Transmitted by the expert from the United States of America
(Agenda item B.1.1, Regulation No. 14)

Per TRANS/WP.29/GRSP/34, para. 16, these Figures 3 and 4 from FMVSS No. 225 are submitted to replace Figures 6 and 7 in Regulation No. 14.

Figure 3 -- Side View, User-ready Tether Anchorage Location

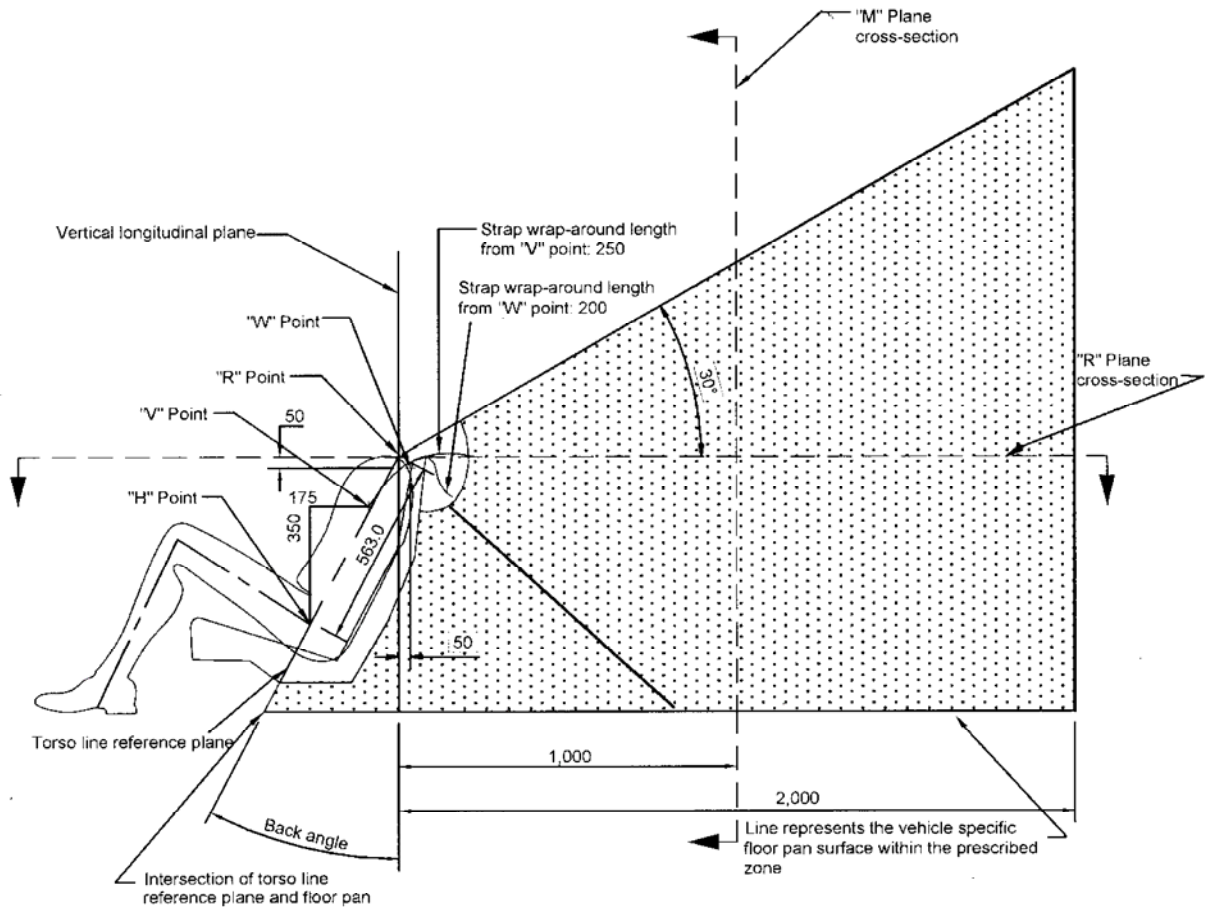
16. GRSP requested the secretariat to correct figure 4 of TRANS/WP.29/931 as indicated in informal document No. 20 regarding the distance between lower anchorages. It was also requested that the tether shaded zones in figures 6 and 7 of TRANS/WP.29/931 be corrected to match figures 3 and 4 of FMVSS No. 225. The expert from the United States of America was requested to verify the corrections proposed in informal document No. 20 and to provide the corrected figures for the next session.
